Access Compliance Report Public Rights-of-Way (Pedestrian Signals)

Main Street: **PROSPECT_ST** Cross Street: **BOND_AVE** Location: **E**

ADA ID: **SGAT211028084646** Signal Type: **One Push Button-Non APS** Overall Compliance: **No** Severity Scores: **BTN 1: 35** **BTN 2: N/A** **No BTN: N/A**

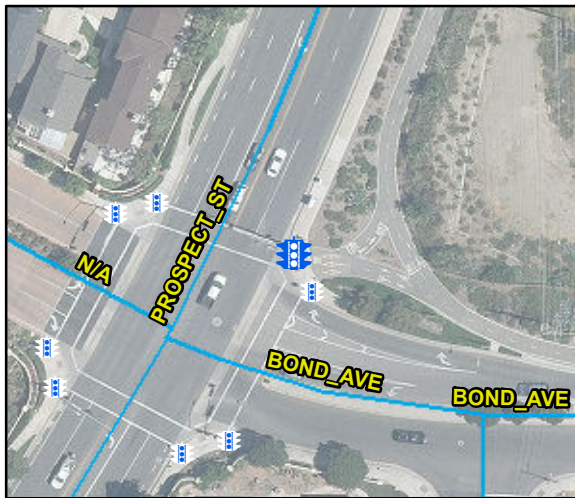
OC Std/PROW: **R404.2, R404.3, MUTCD 4e.08**

Possible Solutions: Replace Signal Push Button With APS Button. Remove and Replace Clear Space.
